DECISION OVERVIEW AND PREFACE

The True North Project Expansion

June 12, 2002

**ALASKA DEPARTMENT OF NATURAL RESOURCES
DIVISION OF MINING, LAND AND WATER**

Figure 1-2: True North Project, Permitted and Amended Footprint

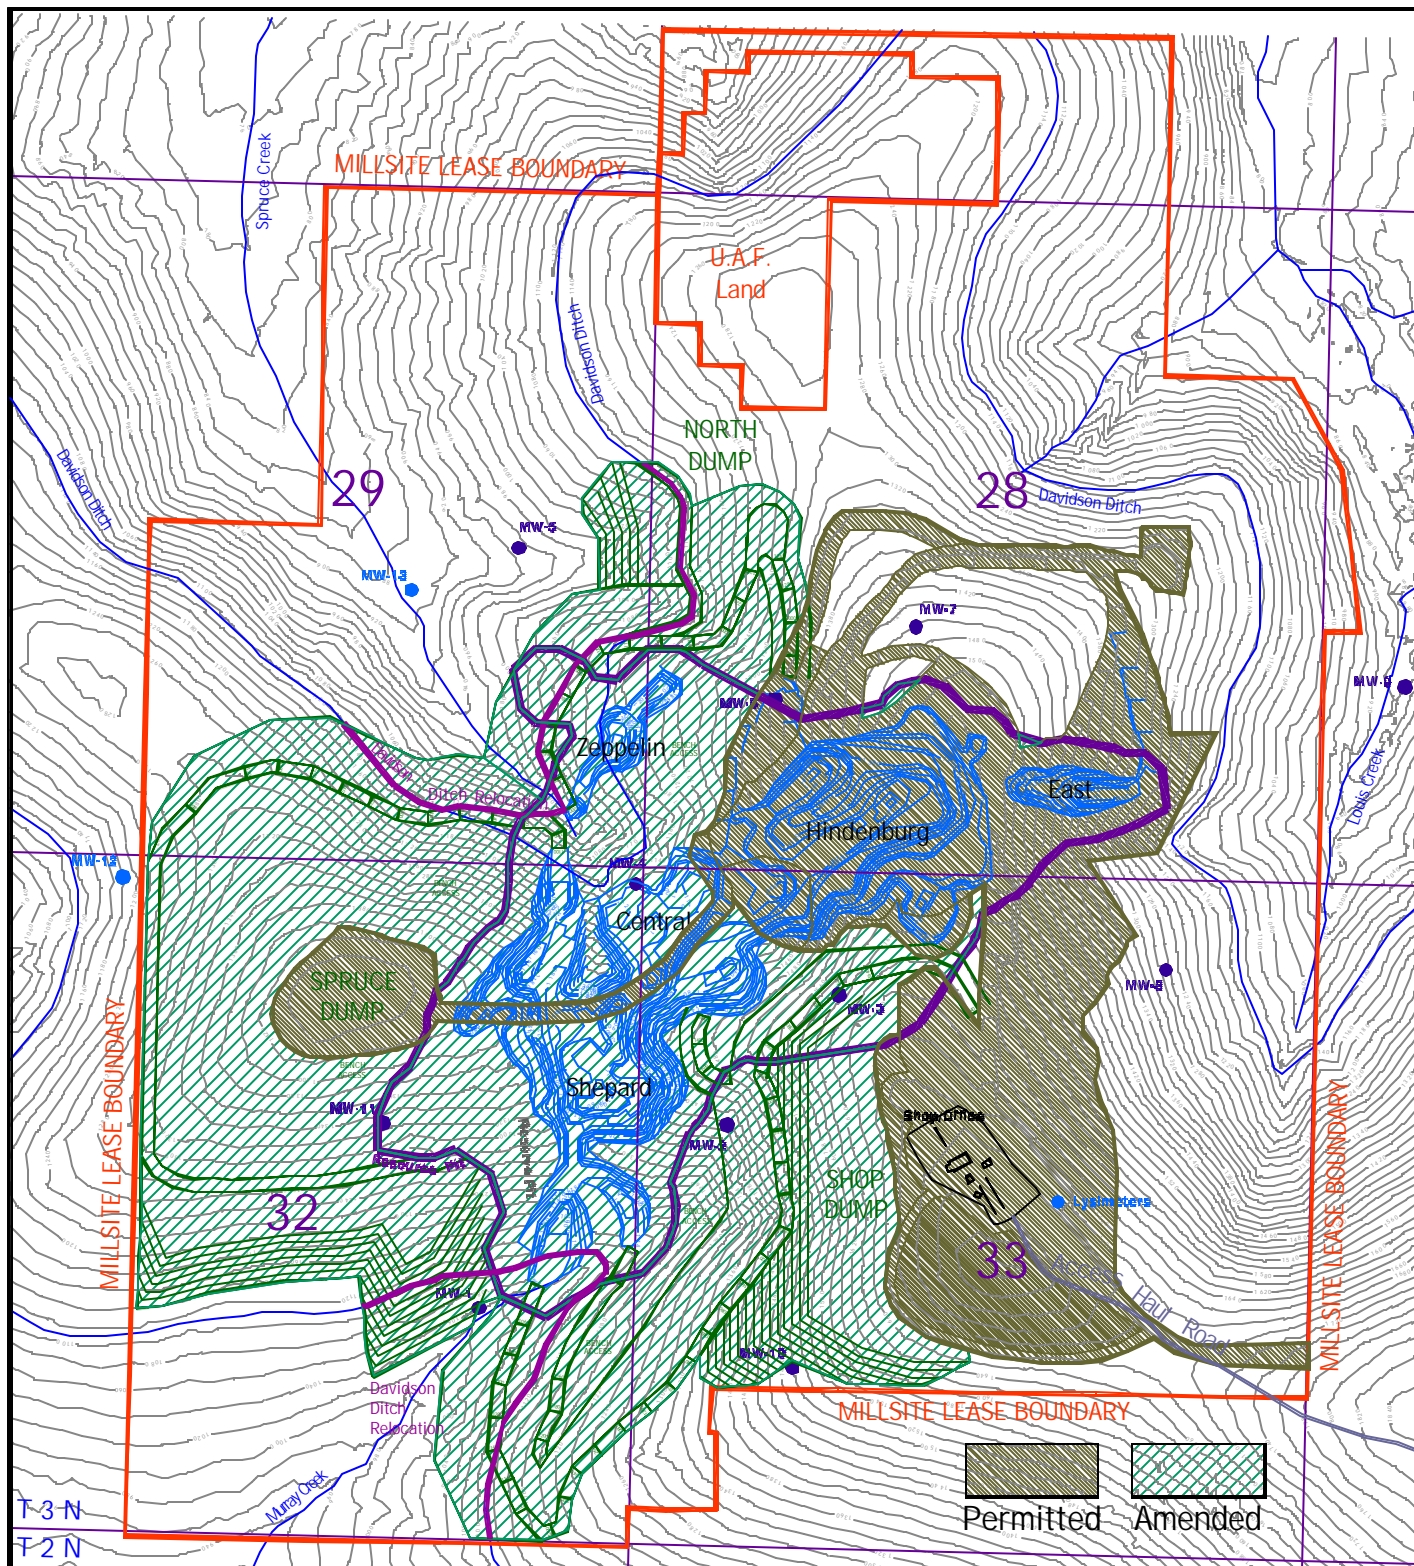
- Oppose impacting any portion of the Davidson Ditch.
- Limit the disturbance to the Davidson Ditch to only $\frac{1}{4}$ mile within the pits.
- Make sure that any terrace built along the ditch contour is stable.
- Maps show that another portion of the ditch in Murray Creek will be impacted also.
- FGMI should leave a 150' buffer around the Mother Lode cabin.
- Access to the Dome Creek Siphon has been severed.
- Some of the Ditch below the Louis Creek rock dump has already been impacted.

Response. After reviewing the application submitted by FGMI, it was determined that the maps were in error by not showing a portion of the Davidson Ditch that would be impacted in the Murray Creek drainage. The maps have all been corrected, and
